MEMORANDUM

From:	Built Heritage Officer		
Service	Green Infrastructure	App No:	252252 + 252253
Address:	L' Ortolan Restaurant, Church Lane, Shinfield, RG2 9BY		
Proposal:	252252: Householder application for the proposed erection of a rooftop extension with terrace decking to the existing main building, alongside alterations to the fenestration; the erection of a rooftop infill extension to the annex building; the erection of a detached single-storey garage with dual-pitched tiled roof and facing brickwork and stone/render to match the main dwelling; landscaping and parking alterations; and the demolition of the existing single- storey rear kitchen/service extension 252253: Listed Building Consent for the proposed erection of a rooftop extension with terrace decking to the existing main building, alongside changes to fenestration; erection of a rooftop infill extension to the annex building; erection of a detached single storey garage with dual pitched tiled roof and facing brickwork and stone/render to match the main dwelling; landscaping and parking alterations; following demolition of existing single storey rear extension.

Summary Of Recommendations

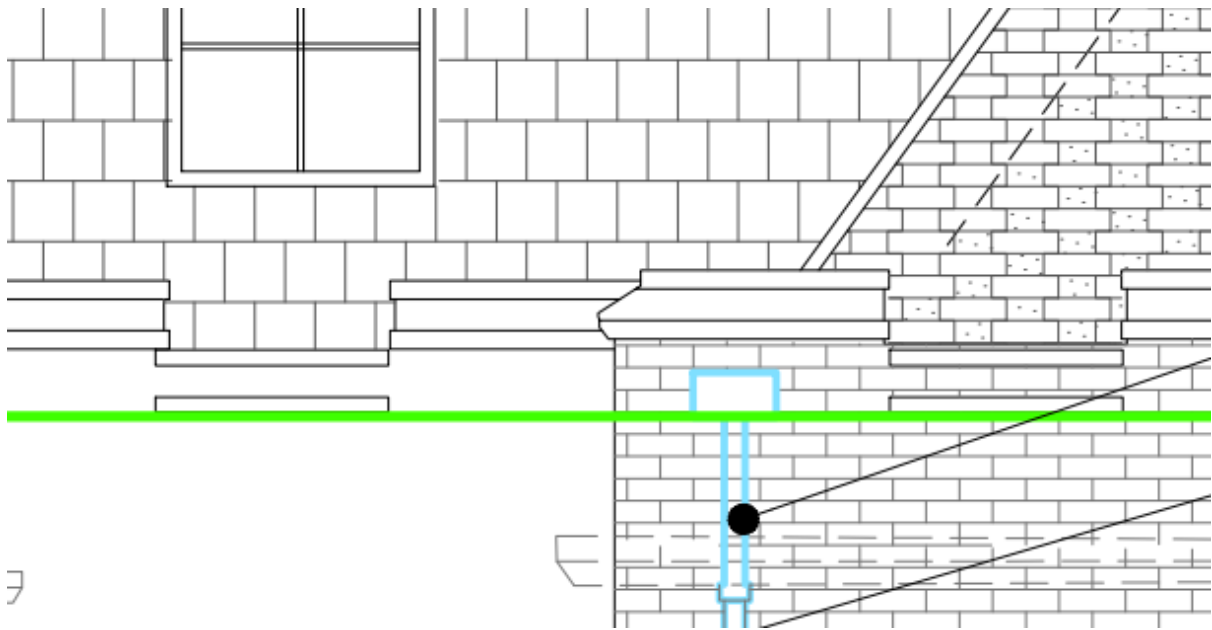
Enlarged extracts of drawing P15 Rev.B showing front and rear parapet walling detailing. – it is however not clear what is happening with respect to the lower sections of the parapet walling on front elevation that appears to show as drawn a single course of brickwork over a thin detail. Whilst on the rear elevation is shown a flat narrow coping to the lower section of the parapet walling with another thin flat coping detail below separated by a single course of bricks.

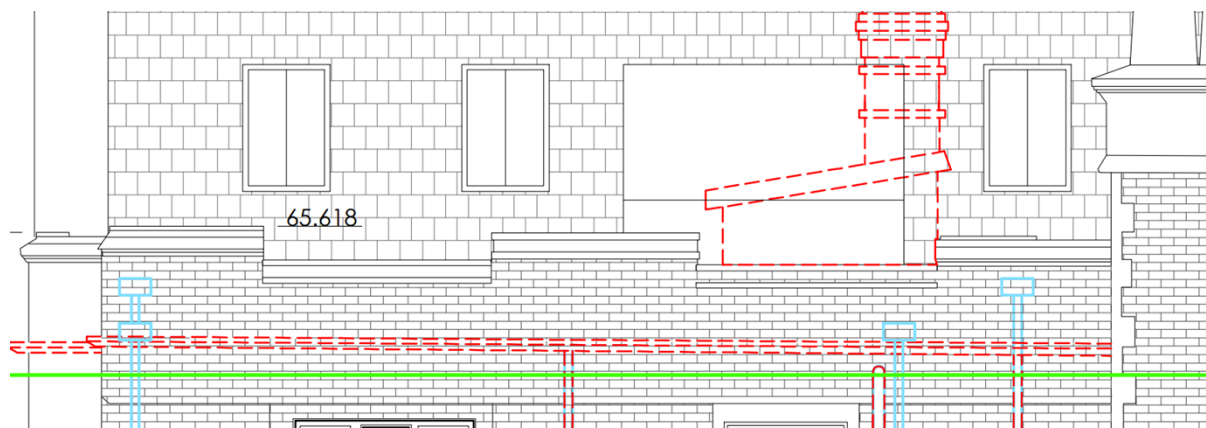
As depicted in the side elevations (P16 Rev. B) and roof plan (P14 Rev. B) appear to depict the front and rear gable ends of the rooftop extension extending out on top of the coping detail of the parapet walling to be in line with masonry walling of the elevations. This is considered to be a somewhat poor detailing in this case. Ideally the ends of the roof preferably should be brought in to be rear of the parapet coping in order to visually better frame the ends of the building.

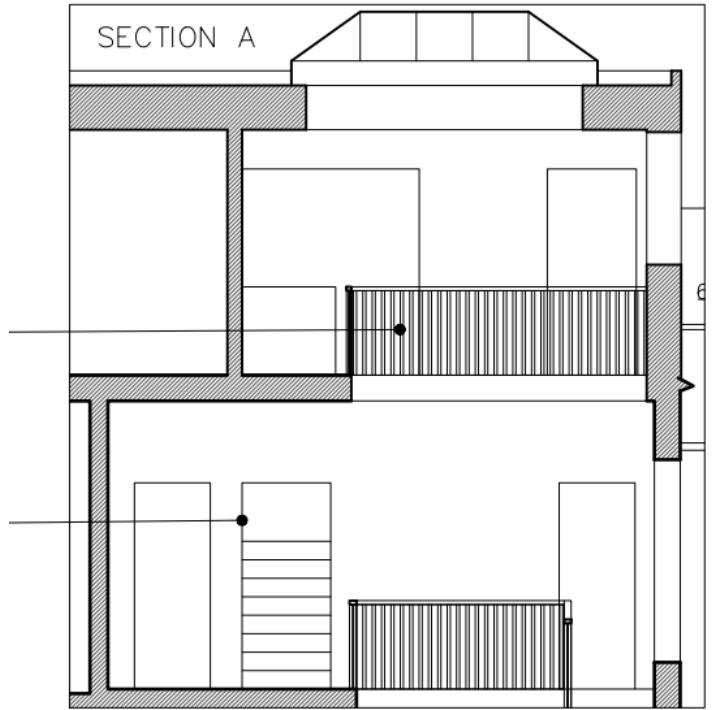
The section detailing the manner in which the roof along the sides of the building would be formed behind the parapet walling so as to include a hidden drainage channel is acceptable in principle however the form of the parapet is shown as being quite different to what is presently there, which is only one brick length thick and capped with a roll-top 'stone' coping.

Section A - extract from drawing P13 Rev. B - the section drawing does not answer the questioned raised with respect to what the end elevation to the rooms to the front of the rooftop extension are to be. Also, it is not clear what the shaded triangle projection on the rear elevation is meant to indicate (is this the coping to the rear)?

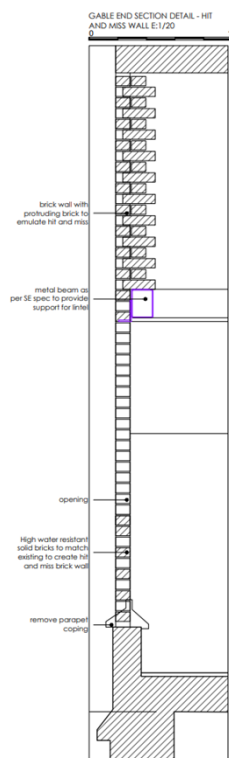
Extract from drawing P16 Rev.B would appear to imply the brick wide hit a& miss lattice gable end walling is to be built off seemingly the existing parapet walling, with the coping whilst shown stated to be removed and not kept. However, on the front and rear elevations of drawing P15 Rev.B show the coping detail.

Also, with the cross-section it is not clear with respect the brick eaves to the gable whether these are to be flush with the end of the roof or with a setback to give an overhang?

In terms of a single brick depth hit and miss lattice walling the gable end there is still concern here as to how safe such an arrangement would be.
